# REMEDIAL ACTION CONSTRUCTION COMPLETION REPORT

# VOLUME II AS-BUILT DRAWINGS & DESIGN CHANGE FORMS

Pine Street Canal Superfund Site Burlington, Vermont

#### **DESIGN CHANGE FORMS**

Maps comparing approved design and proposed changes: Design Change #5, Area 7 Grading Plan - Northeast side Design Change #8, Area 7 Grading Plan - Southwest side Design Change #8, Area 7 Grading Plan - Northwest side

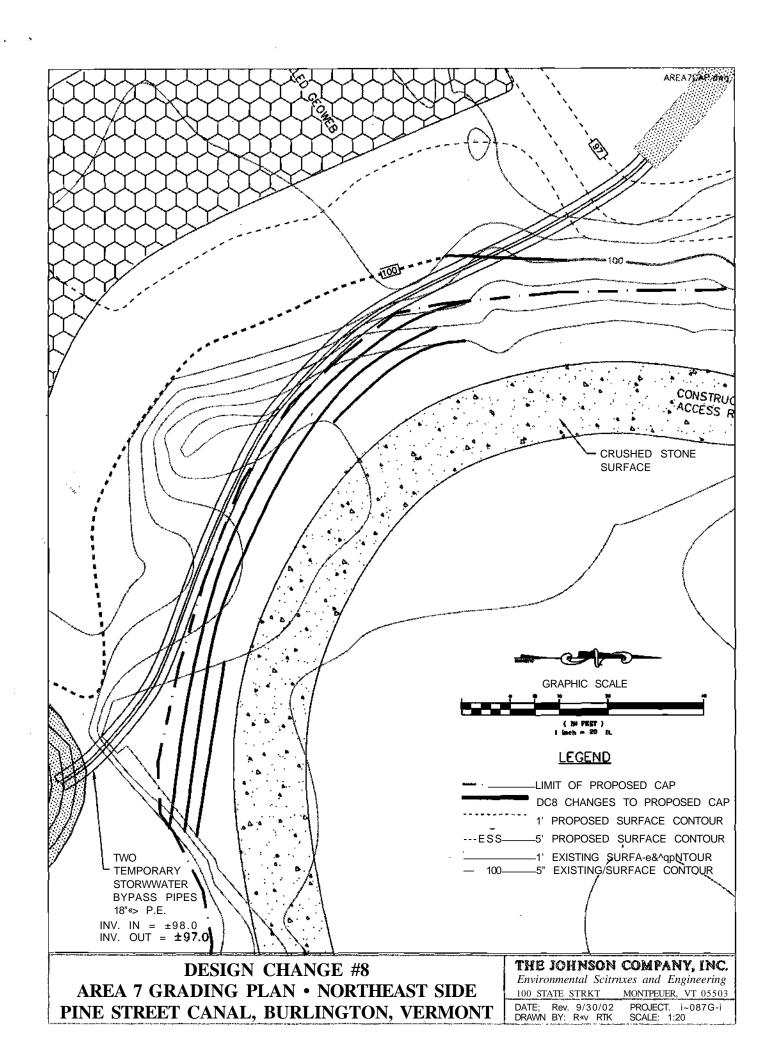
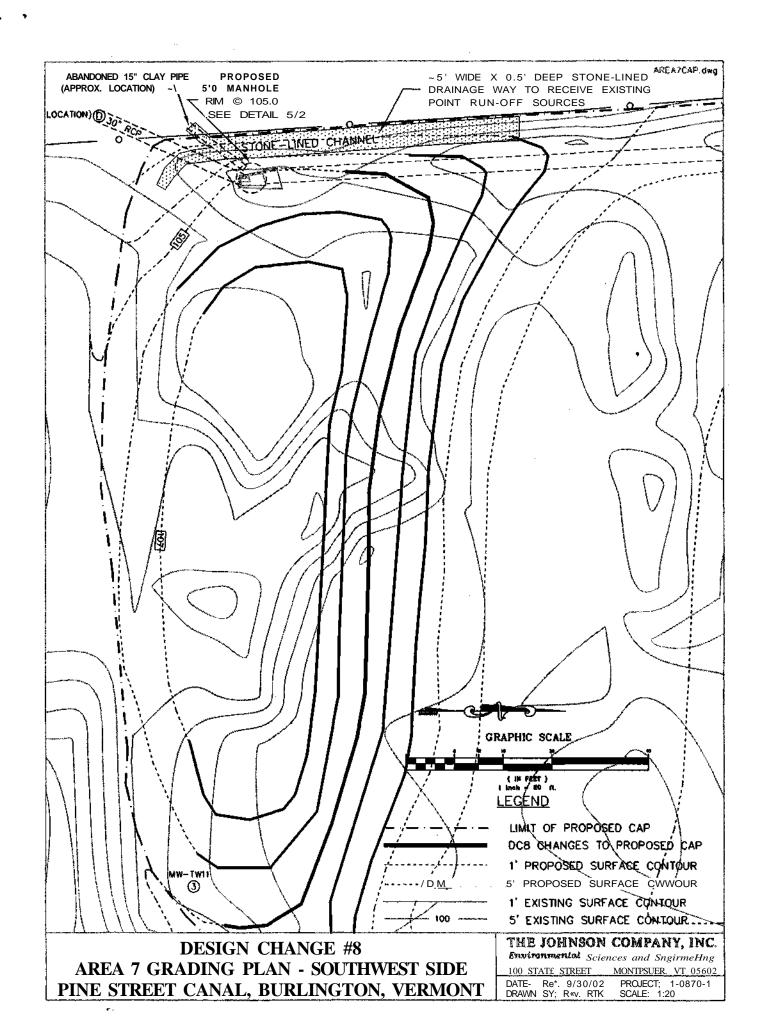
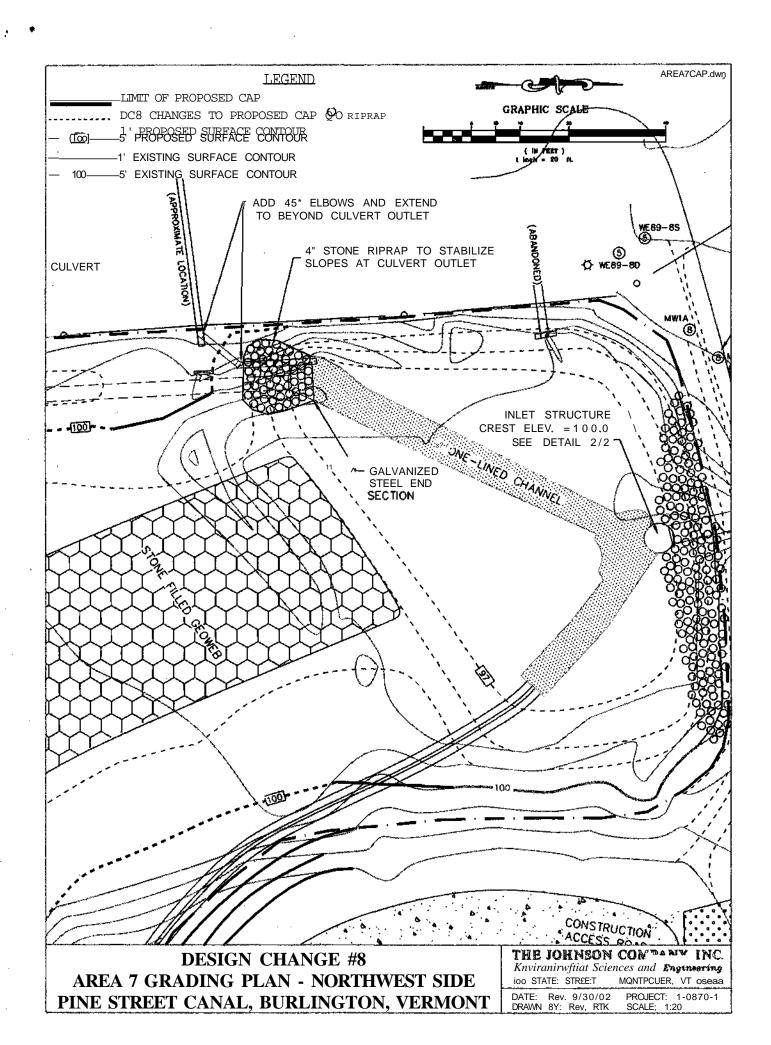
A minor design change for the Area 7 grading plan is necessary to accommodate existing field conditions and to improve erosion resistence. The design change includes three parts: 1) revise the slope of the native soil outside the capped area on the northeast side and remove relict grading contours; 2) revise the slope of the capped uplands area on the southwest side; and 3) provide erosion resistant materials in areas receiving local concentrated storm water runoff from off-site (portions of the DPW yard and Gilbane parking). The rationale for, details of, and expected consequences of, these changes are provided below. The approved design is shown on Sheet 1 of 8 of the approved Design Drawings.

The grading for the northeast side of Area 7 requires a cut of up to two feet of uncontaminated materials outside the cap in order to provide a smooth transition between the uncapped to the capped surfaces (please refer to the attached *Design Change #8*, *Area 7 Grading Plan - Northeast side*). The approved grading plan specifies a slope of approximately 20% (1:5). The proposed change is to increase the slope to a maximum of approximately 33% (1:3). This change will reduce the volume of "clean" un-capped soils which will need to be excavated. This change in grading only affects elevations of 101 ft NGVD and above, so the wetlands balance, and areal extent of cap remain unchanged.

The other change included in this part is to remove relict mounds which were present at the downstream end of the Area 7 waterway. The grading change is indicated by two bold 99 and 100 ft NGVD contour segments, as shown on the attached *Design Change #8*, *Area 7 Grading Plan - Northwest side*. The two mounds which are being cut down (at elevation 100 ft NGVD) are relicts of a historical road which extended northeast/southwest across Area 7, and which was removed for the construction of the waterway. Removal of the mounds will improve the hydraulic capacity of the waterway and better flow distribution through the wetlands. There are no expected adverse consequences to this proposed change.

The southwest side of Area 7 was designated as the receiving area for phragmites root mass, chipped wood, and sediments which were excavated from other portions of Area 7 in order to meet the design grades. This mound of materials will be capped in the same manner as the rest of Area 7. The approved design includes a 10% (1:10) slope for the northern side of the mound. The proposed change is to increase the slope above elevation 102 ft NGVD to as much as 20% (1:5). This change may be necessary in order to accommodate the volume of material which has been excavated. This change does not include any increase in the maximum elevation of the mound. The attached *Design Change #8*, *Area 7 Grading Plan - Southwest side*, shows the elevation contours representing the maximum slope which would be constructed if this change is approved. The actual as-built slope is likely to be somewhere between 10% and 20%, depending upon the final volume of materials excavated in other portions of Area 7.

Part 3: Provide erosion resistant materials in areas receiving local concentrated storm water runoff Existing off-site grades on the Department of Public Works and Gilbane properties concentrates stormwater runoff from local areas so that it flows towards the new Gilbane manhole (please refer to the attached *Design Change* #5, *Area 7 Grading Plan - South side*). This runoff may cause local erosion of the cap prior to establishment of vegetation if it is constructed of sand and topsoil as currently specified. The proposed change is to provide a stone-lined swale, approximately five feet wide (or less) and 0.5 feet deep in place of the 0.5 foot thick topsoil specified in the approved plans. This swale will collect the concentrated runoff, and guide it northwards approximately 60 feet along the western edge of Area 7 until it can be dispersed across a wide flat area of the cap. This change

Also included in this part is the addition of erosion resistant materials (stone) around the downstream (northern) end of the newly installed 36-inch Gilbane culvert (please refer to the attached *Design Change* #5, *Area 7 Grading Plan - Northwest side* for the proposed location of stone placement). The placement of erosion resistant materials at this location will reduce the potential for undermining of the culvert. This work was suggested by Jean Choi of EPA. There are no expected adverse consequences to this proposed change.
